# GENESEE COUNTY PLANNING BOARD REFERRALS NOTICE OF FINAL ACTION

GCDP Referral ID **T-01-BER-3-22**  
Review Date **3/10/2022**

**BERGEN, T.**  
**PLANNING BOARD**  
**Jacob Berardi/ Apple Tree Acres LLC**  
**Site Plan Review**  
**Site Plan Review to construct a 50,000 sq. ft. (100 x 500 ft.) warehouse building.**

**RE: 50,000 SF OFFICE AND WAREHOUSE/MANUFACTURING FACILITY  
APPLE TREE CORPORATE BUSINESS PARK – 7001 APPLE TREE AVENUE  
PRELIMINARY SITE PLAN AND SWPPP REVIEW  
MRB PROJECT NO. 0202.18000.000**

**EROSION CONTROL PLAN**  
SCALE: 1"=50'

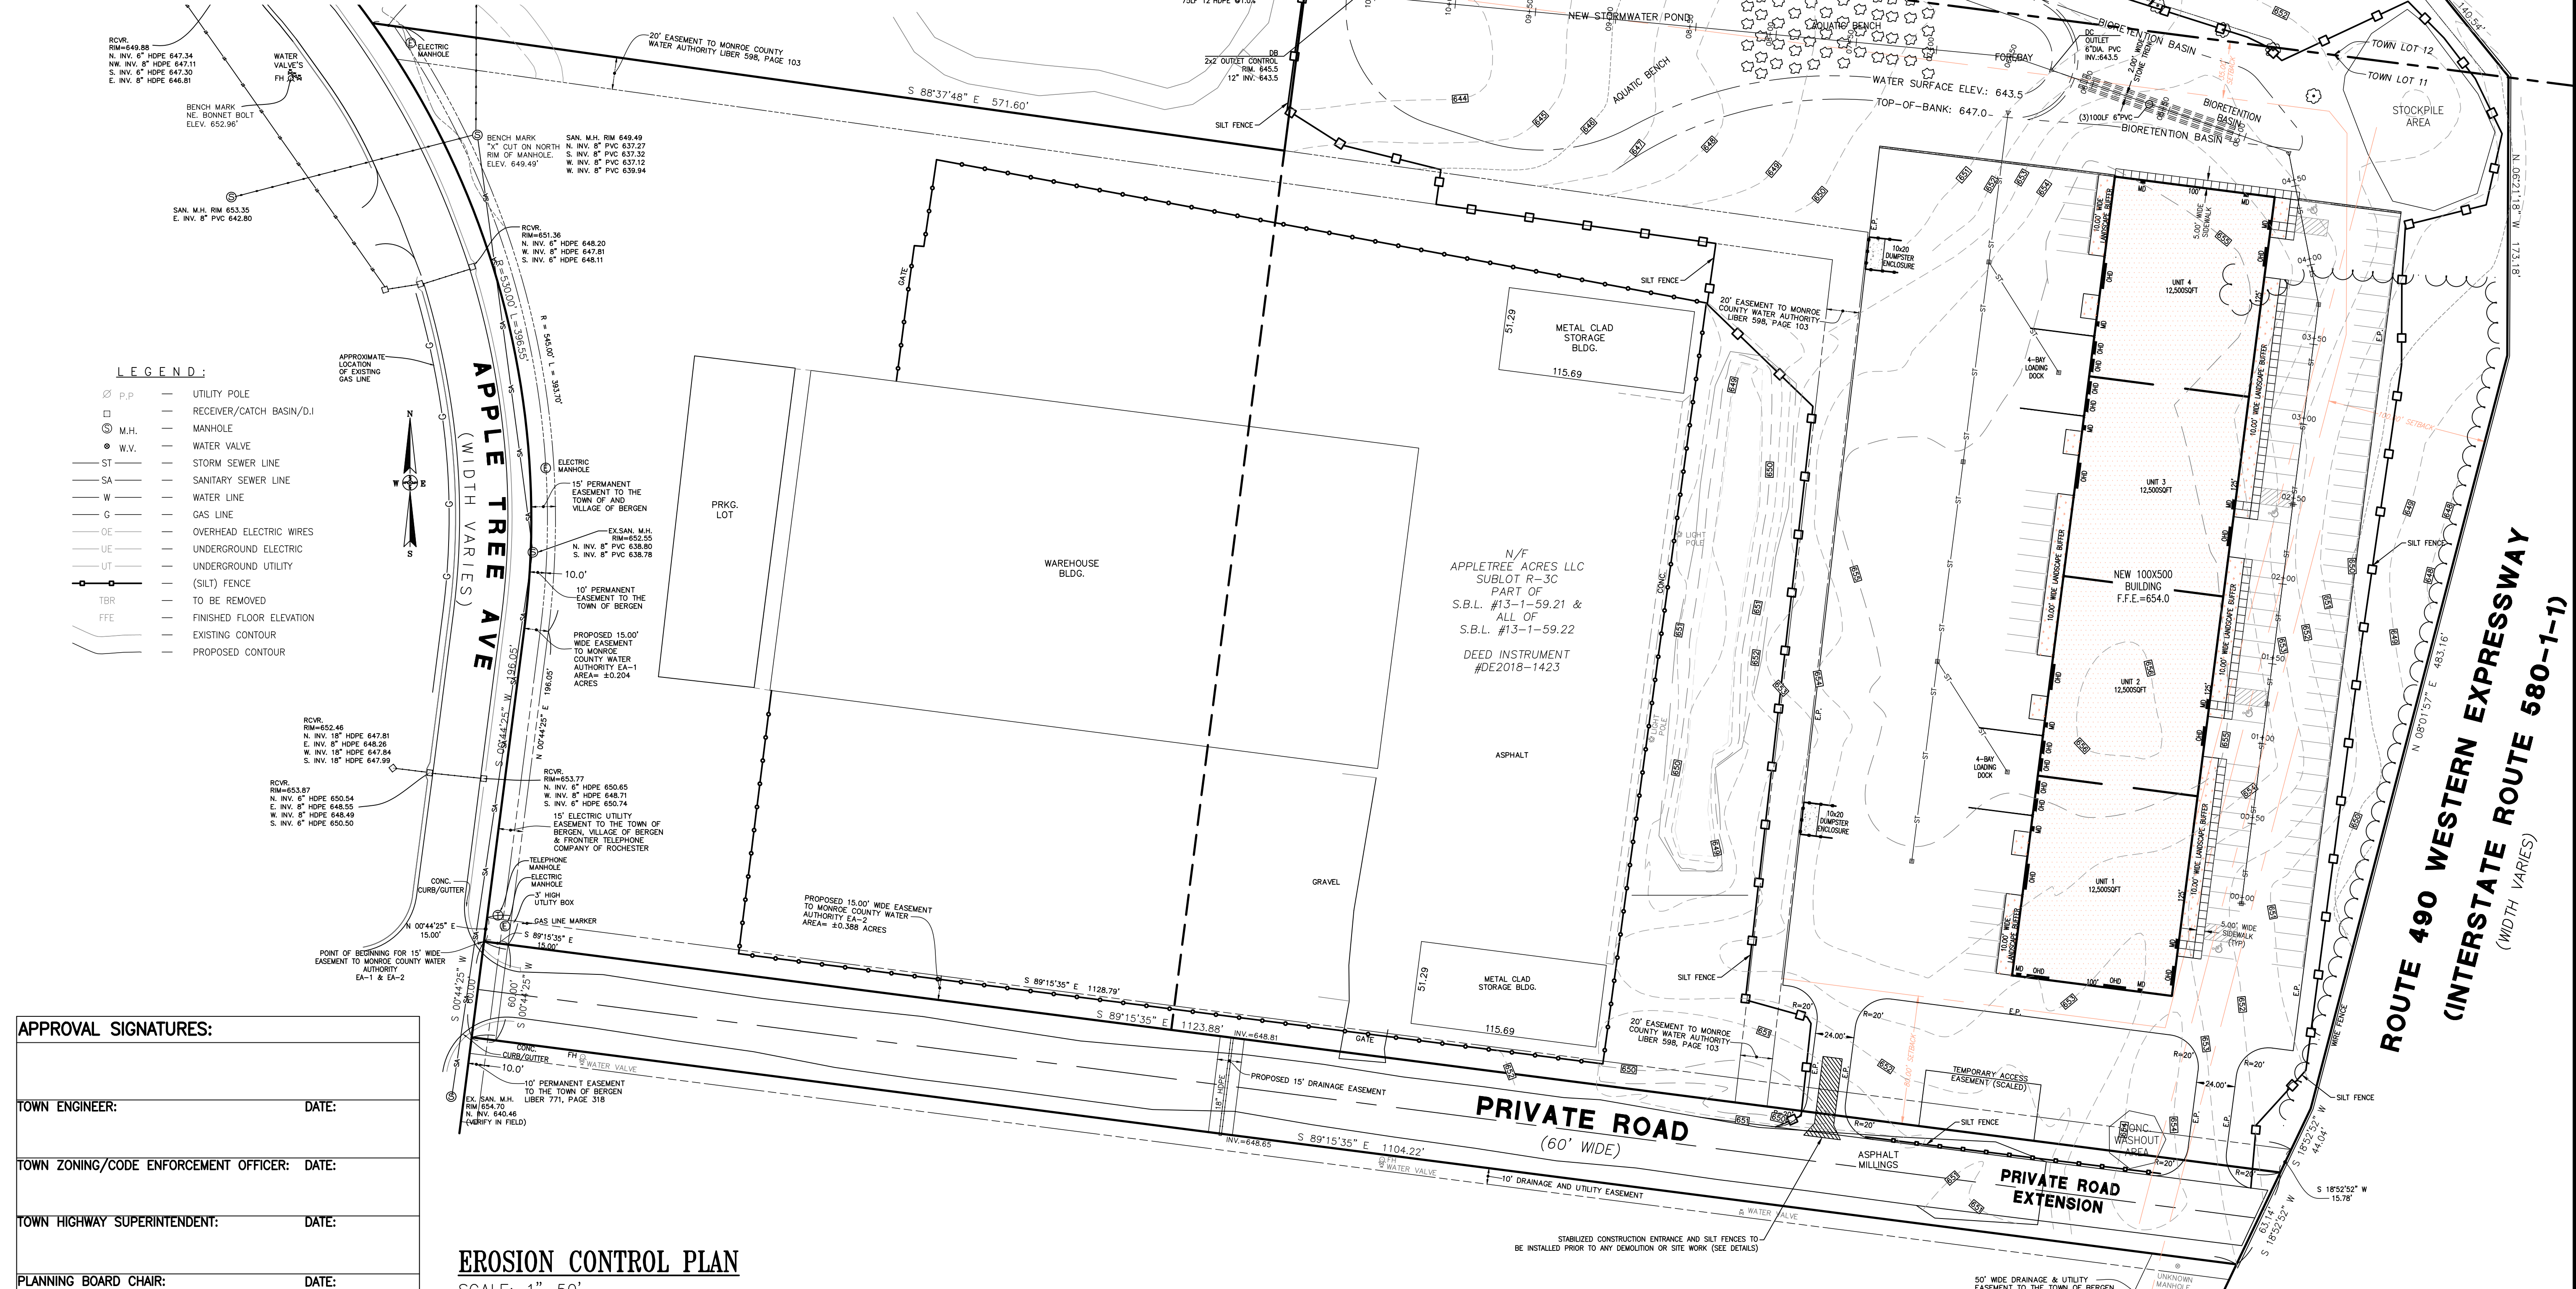
9. The concrete washout and Topsoil stockpile location should be more visible on the plans. The current gray scale depiction is not clear on the plans.

17. Spot Elevations added.
18. Concrete washout area added.
19. Topsoil Stockpile Location added.
20. Clearing and disturbance boundaries were shown on plans.
